Access Compliance Report

Public Rights-of-Way

(Curb Ramps)

Intersection ID: 12066	Main Street: WEYLAND_AV	Cross Street: MARLOWE_AV	Location: NE
ADA ID: A43DB55776BC	Ramp Type: PerpDiag	Initial Pass/Fail: Fail	Overall Compliance: No
		Severity Score: 48.75

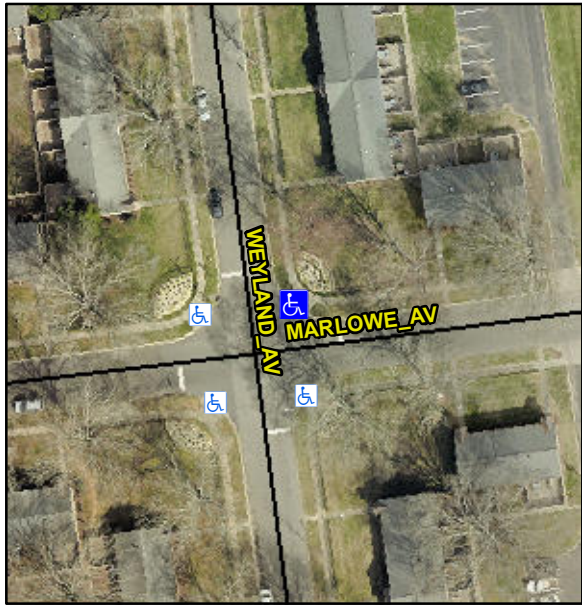
Codes/Mitigation Info/Possible Solution		Field Measurements/Component Compliance						
	Possible Solutions:		Compliance	Description	Data	Compliance	Description	Data
	Remove & Replace Curb Ramp With Two New Directional Ramps or Equivalent.		N/A	Ramp Length (in)	73.0	No	Ramp Slope (%)	8.5
			No	Ramp Width (in)	31.0	No	Ramp XSlope (%)	2.5
			N/A	Flare Type LT	N/A	N/A	Flare Type RT	N/A
			N/A	Flare Slope LT (%)	N/A	N/A	Flare Slope RT (%)	N/A
			N/A	Flare Traversable LT?	N/A	N/A	Flare Traversable RT?	N/A
			N/A	Landing Length (in)	N/A	N/A	DWS Provided?	N/A
			N/A	Landing Width (in)	N/A	N/A	DWS Contrast?	N/A
			N/A	Landing Slope (%)	N/A	N/A	DWS Length (in)	N/A
			N/A	Landing X Slope (%)	N/A	N/A	DWS Full Width?	N/A
<p>Surveyor Notes:</p> <p>N/A</p> <p>PROW/ADA:</p> <p>Not Found, R304.5.1, R304.2.2, R304.5.3</p>			N/A	Landing Curb? (Y/N)	N/A	N/A	DWS Offset (in)	N/A
			N/A	Shared Landing?	N/A			
			N/A	Gutter Ponding?	N/A	N/A	Gutter Slope (%)	N/A

N/A	Gutter Lip Ht (in)	N/A	N/A	Gutter X Slope (%)	N/A
			N/A	Painted X Walk1?	No	N/A	Painted X Walk2?	No
				X Walk 1 Direction	To W		X Walk 2 Direction	To S
			N/A	X Walk 1 Width (in)	N/A	N/A	X Walk 2 Width (in)	N/A
				X Walk 1 Slope (%)	3.4		X Walk 2 Slope (%)	1.6
				X Walk 1 X Slope (%)	0.5		X Walk 2 X Slope (%)	3.0
			N/A	Ramp inside XWalk1?	N/A	N/A	Ramp inside XWalk2?	N/A
			Road Slope (%)	2.2	N/A	Clear Space?	N/A	
			Road X Slope (%)	3.0	N/A	Clear Space to XWalk (in)	N/A	
		N/A	Any Obstructions?	N/A	N/A	Storm Grate/Utility Hazard?	N/A	
			Obstruction Type			Storm Grate/Utility Type		
				N/A			N/A	
					Yes	Surface Condition? (G/P)	Good
